Knockcronal Wind Farm

Gatecheck Report

Client: Statkraft
Project/Proposal No: 3206
Version: V3
Date: 2021-05-27

Figure 2
Layout A - Intial Turbine Layout

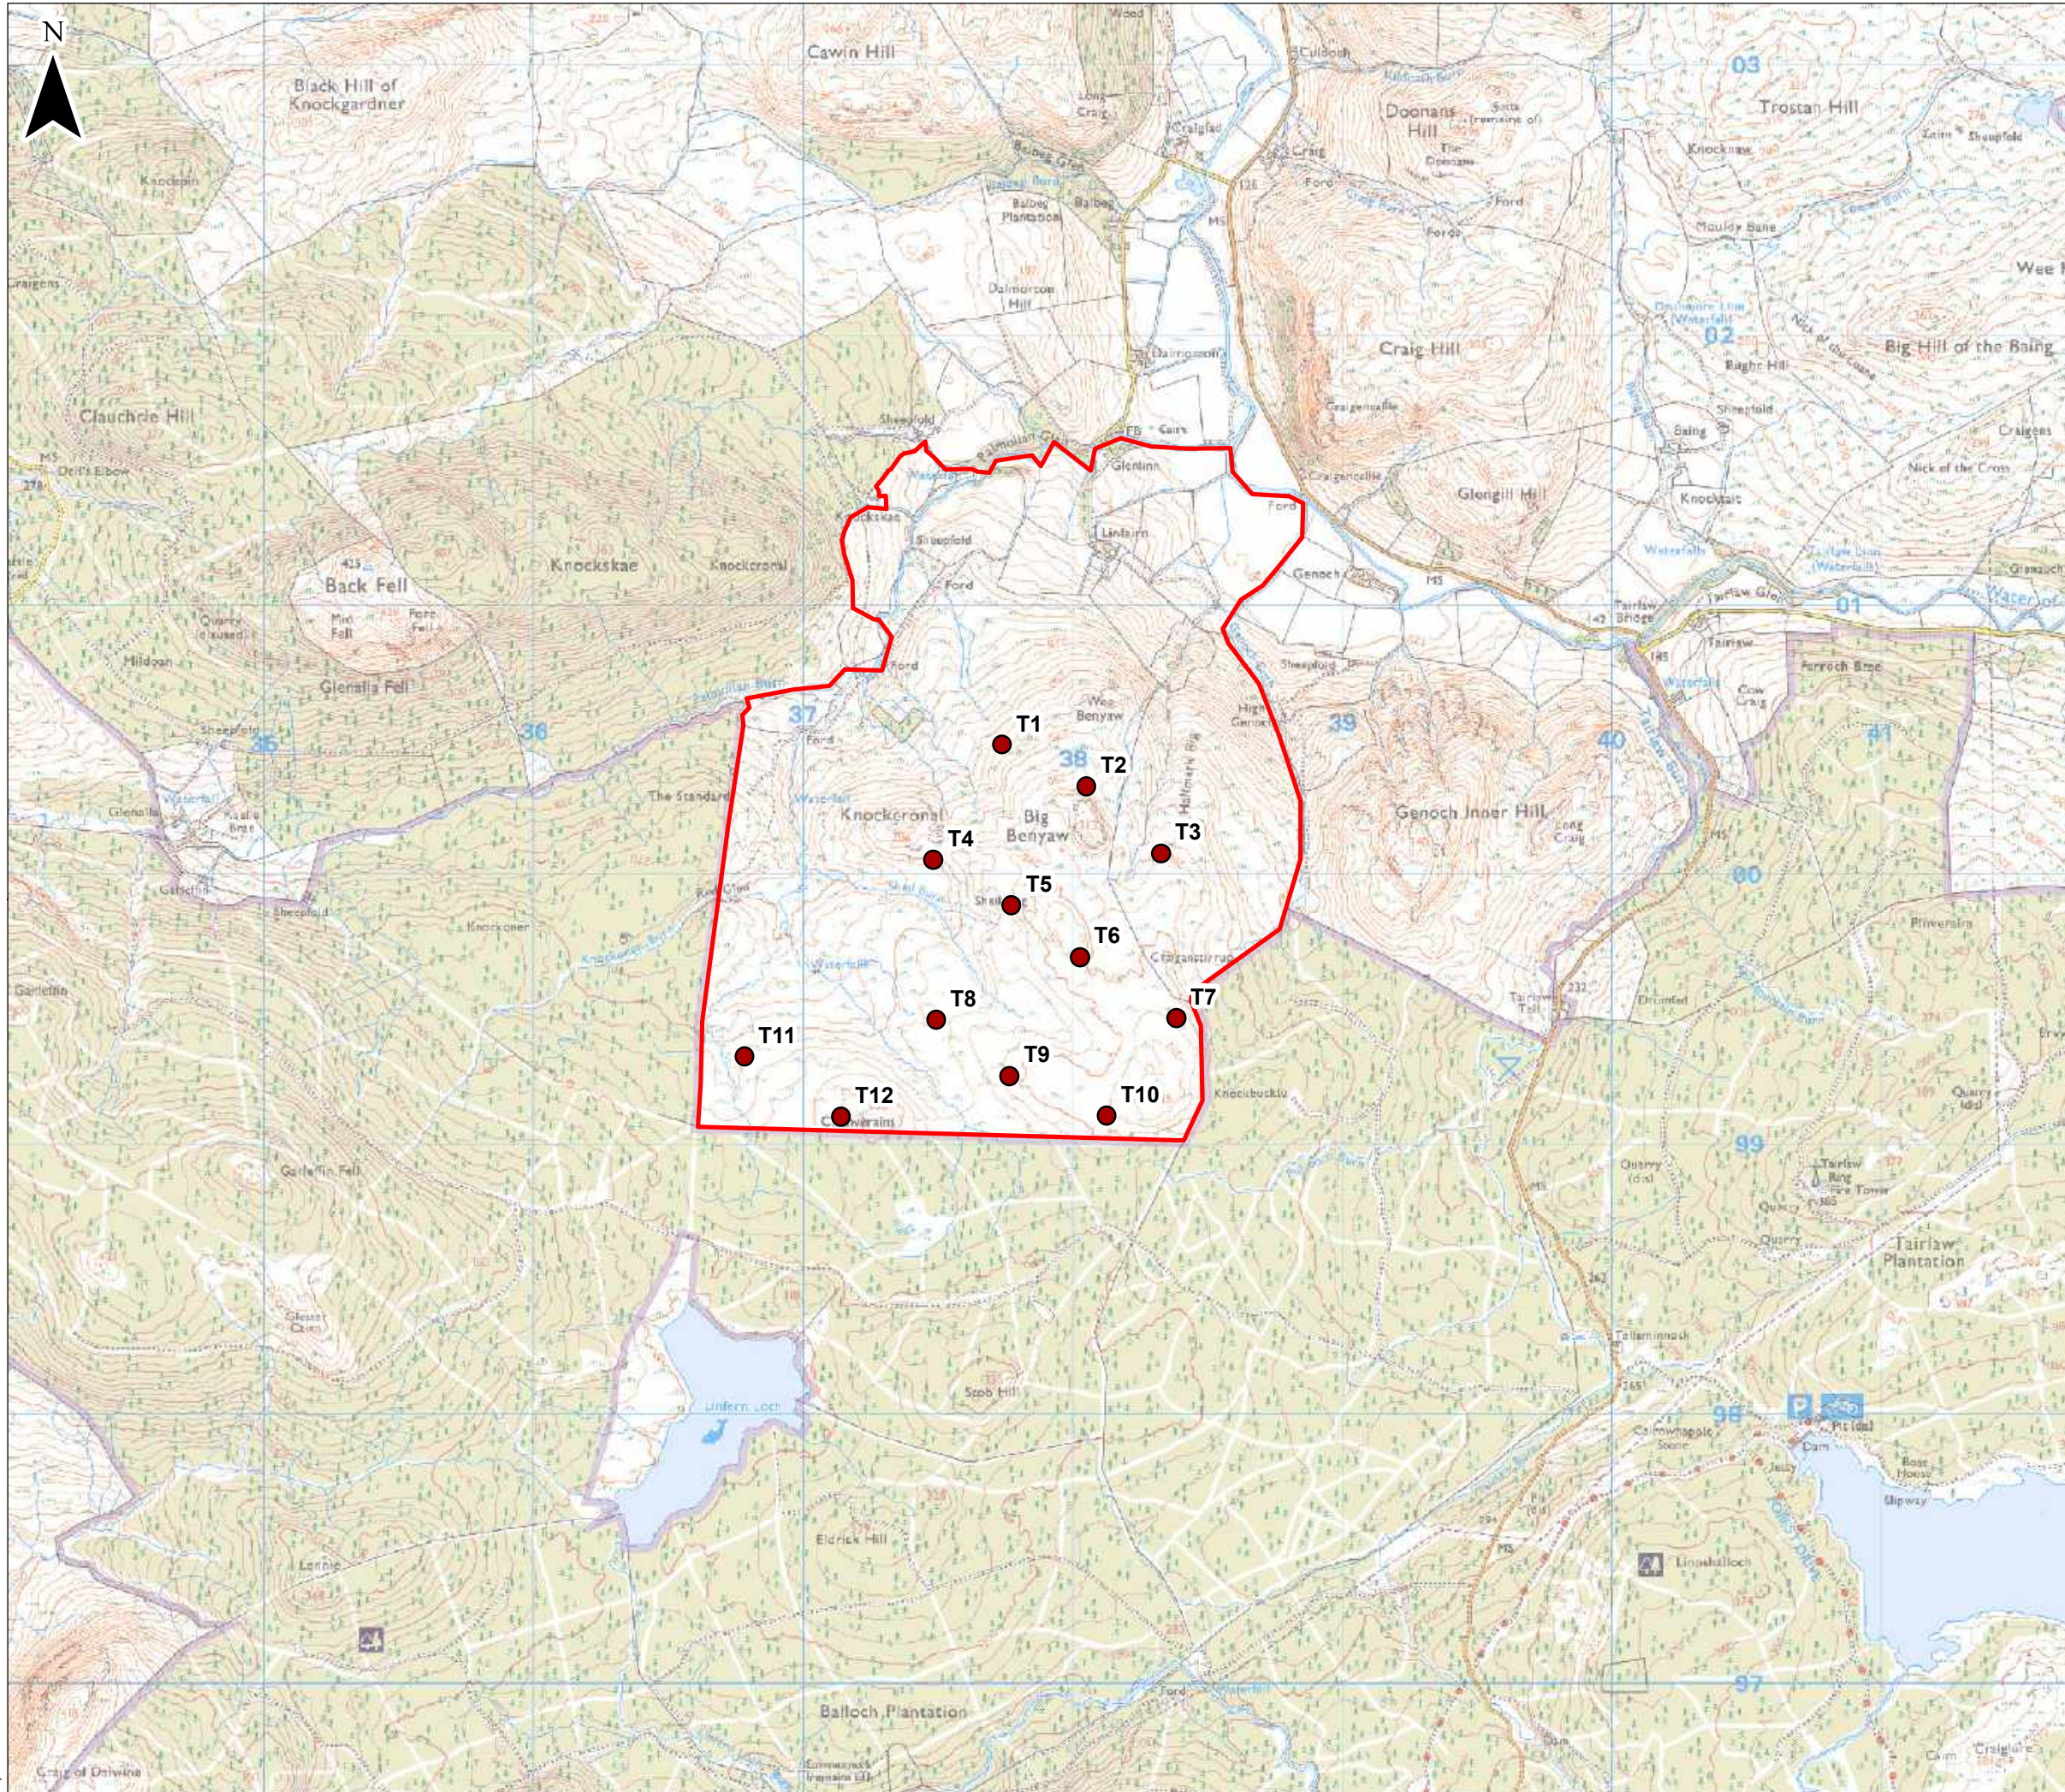
Design Iteration	No. Turbines	Date	Description
A (Figure 2)	12	August 2020	Initial design maximising yield and capacity on the site.
C (Figure 3)	12	August 2020	Original Scoping Report design which took into account the findings of initial environmental surveys. The northern most turbines were relocated to avoid areas identified as being deep peat.
K (Figure 4)	10	September 2020	This iteration involved the deletion of T2 and T4 to reduce potential noise impact on the property at Knockskae. Remaining turbines were relocated further to the south west of the site and appropriately sited to maintain watercourse buffers and avoid areas of deep peat.
N (Figure 5)	11	October 2020	Movement of turbines in order to increase capacity by allowing one additional turbine to be included in this design iteration, while still maintaining watercourse buffers and an appropriate distance from noise receptors, and avoiding areas of deep peat. Design input from landscape architect (throughout) including draft visualisations from key receptors, helped to ensure iteration would minimise landscape and visual effects, including in the Merrick WLA.

Figure 3
Layout C - Scoping

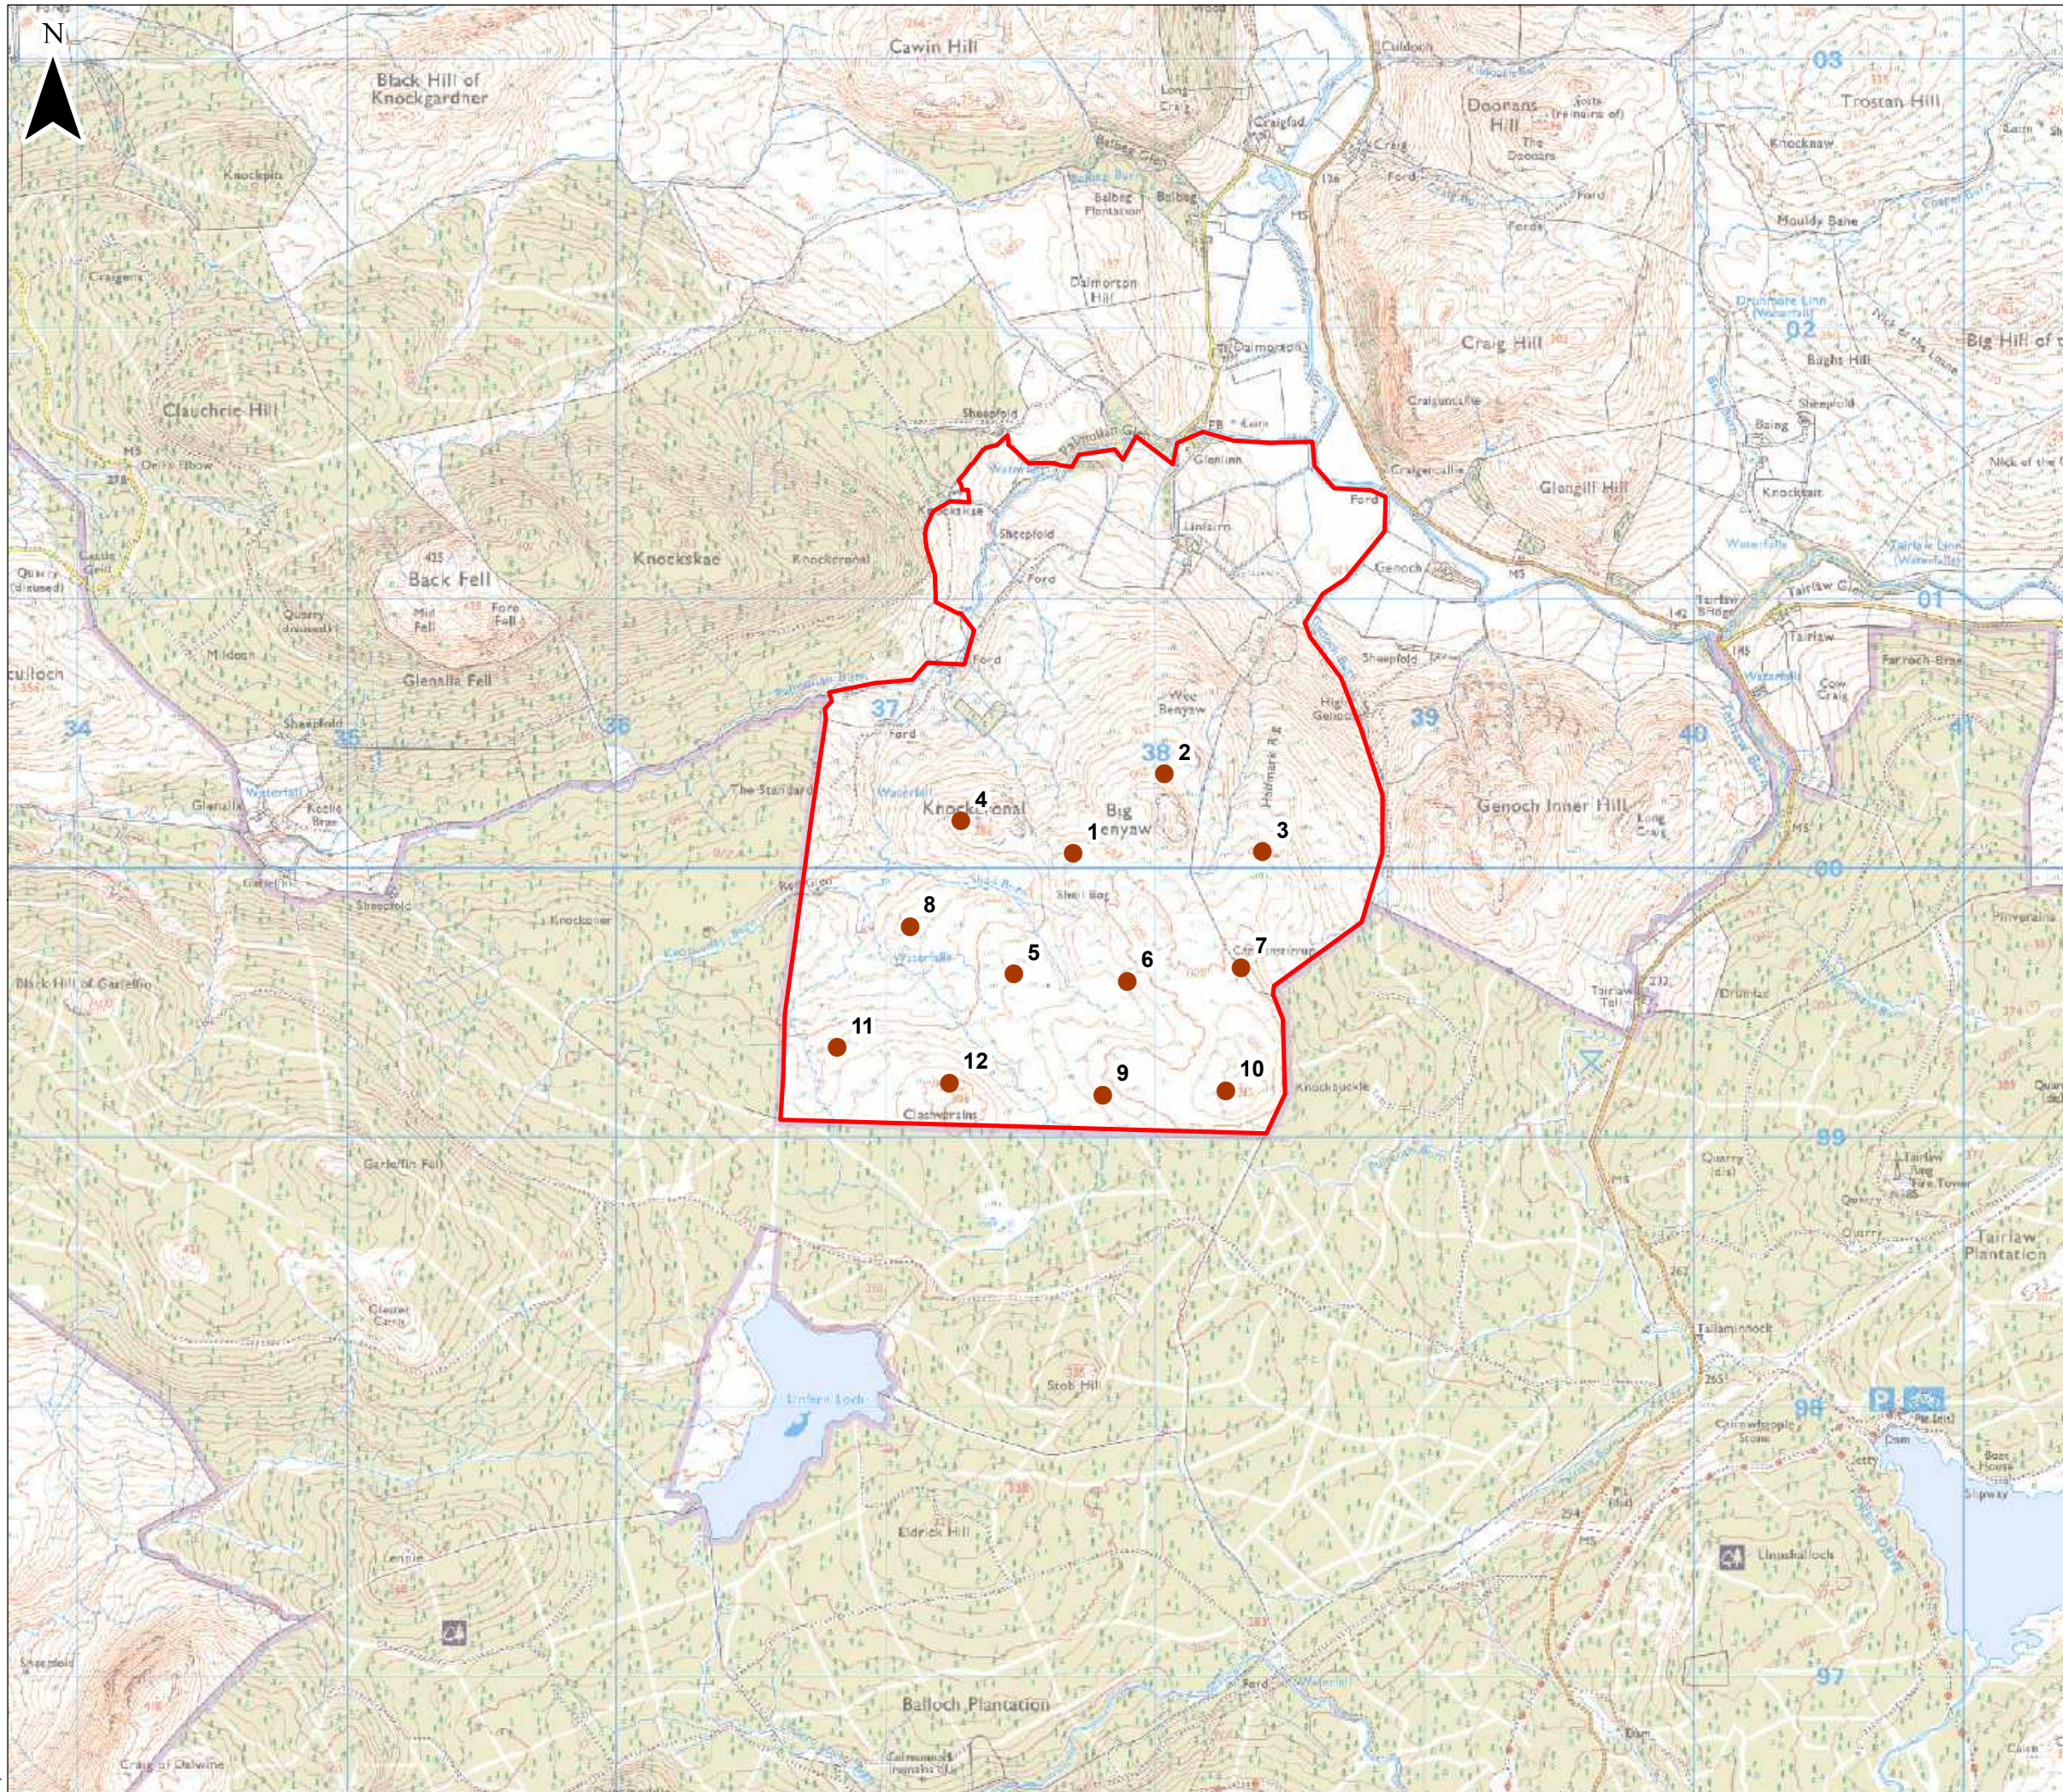
In December 2020, as part of the EIA Scoping Report, the Applicant submitted an indicative turbine layout for the Proposed Development of 12 turbines. This is labelled Layout C (refer to Figure 3) as it had already been subject to initial design iteration work from the initially proposed layout, as some baseline surveys had progressed. Further information is provided in Section 3.2 EIA Scoping Opinion Comments on Design.
